Rezoning Transportation Analysis
Petition Number: Insert Zoning Petition #2021-264
General Location Identifier: 04324115

Revision Log:

Date	Description
04-28-22	First Review (PDM)

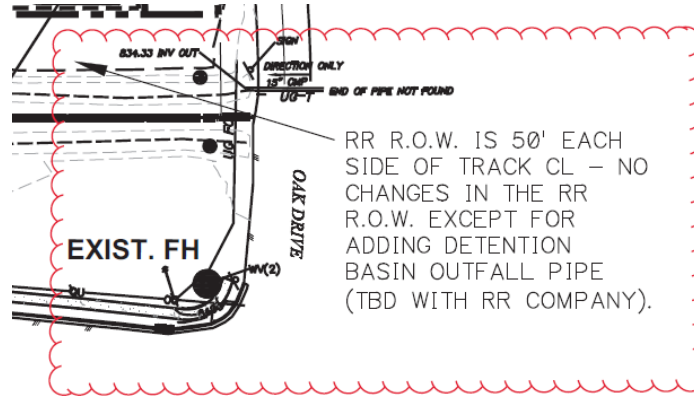
6. Site plan revisions are needed to show the location of the railroad ROW. The existing callout on the plan does not point to any linework on the site plan.

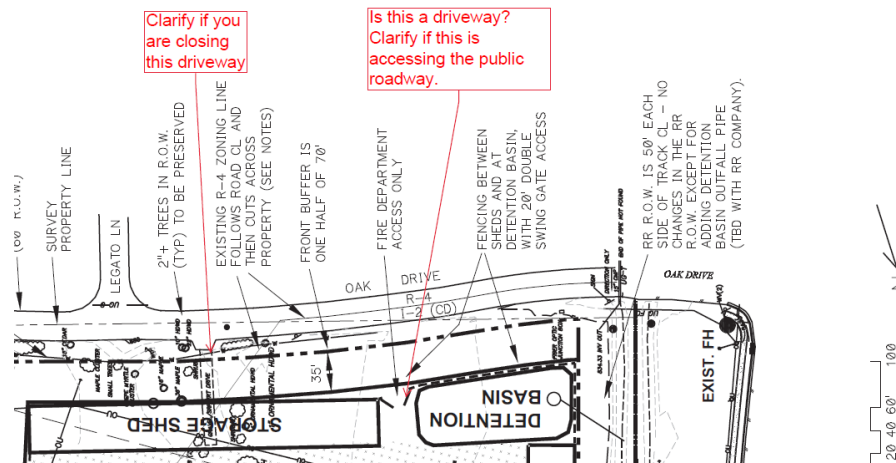
7. Site plan and conditional note(s) revisions are needed to clarify how the proposed access point on Oak Drive will be restricted to Fire Department access only. In addition, revise site plan to show how the driveway will access the public road.
8. Site plan and conditional note(s) revisions are needed to clarify what is happening to the existing gravel driveway on Oak Drive that accesses the site. If the driveway will be closed as part of the project, add a callout to remove the driveway.
